6671A-10

**S E R V I C E N O T E**

**6671A - DC POWER SUPPLY, 0-8 V, 0-220 A, 1760 W.  
GPIB CONTROLLED**

**The four filter capacitors circuit reference (C416-C419) on the A4 AC input board starts leaking electrolyte**

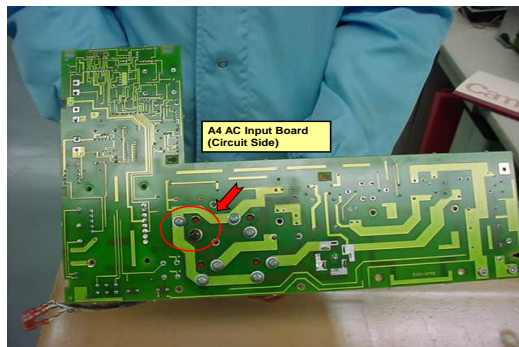
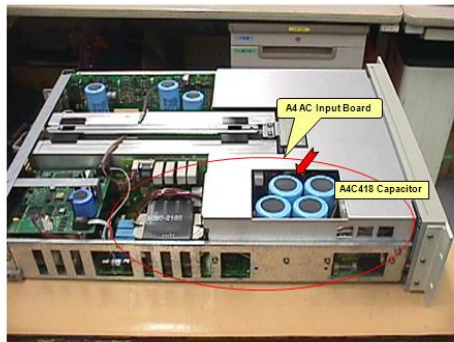
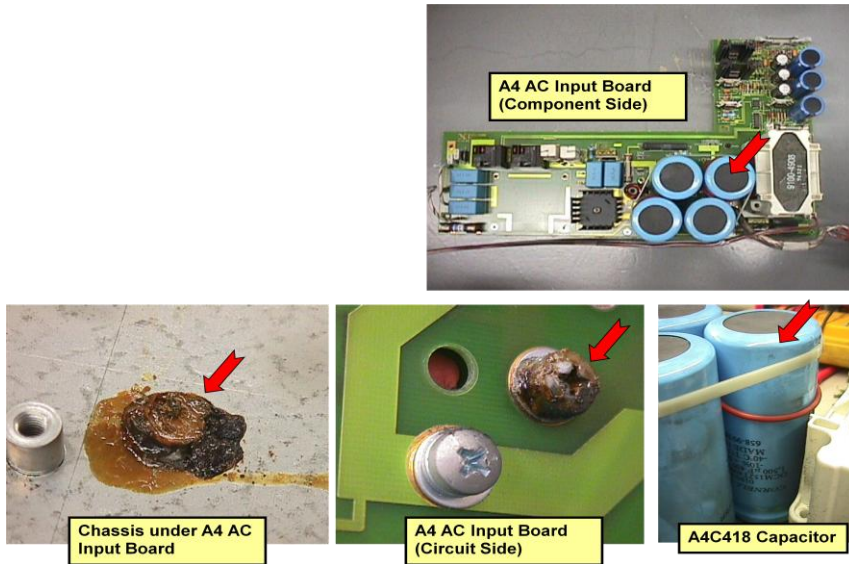
The four filter capacitors circuit reference (C416-C419) on the A4 AC input board starts leaking electrolyte - not through the pressure valve in the bottom as one would expect but through one of the terminal screw bushings.”

The screw P/N 2680-0217 length currently being used was not considered and the length was overlooked. The screw length is 0.375 inches long. We have found that the screw can be 0.055 inches too long and may bottom out causing the tapped hole in the header of the capacitor to become cracked or become broken.

When this happens the electrolyte will slowly leak out over time, and cause the defect described. This situation is even worse due to the capacitor is mounted with the header face down. If the capacitor was mounted header face up a cracked or broken header would not have caused this problem, the electrolyte could not leak out.

1. All affected models and tested assemblies WIP (Work In Process), FGI (Finished Goods Inventory) at SPO (Support Parts Organization) & AMC (Asian Manufacturing Center) has been inspected for capacitors with damaged headers due to the incorrect screw
2. When this repair is being done all of the hardware described above should be replaced (It is NOT recommended that any of the hardware be reused)
3. The following figures can be used when doing the repair.
4. Inspect the assembly as described below.
5. The last figure will aid in the reassembly of the hardware and the capacitors.
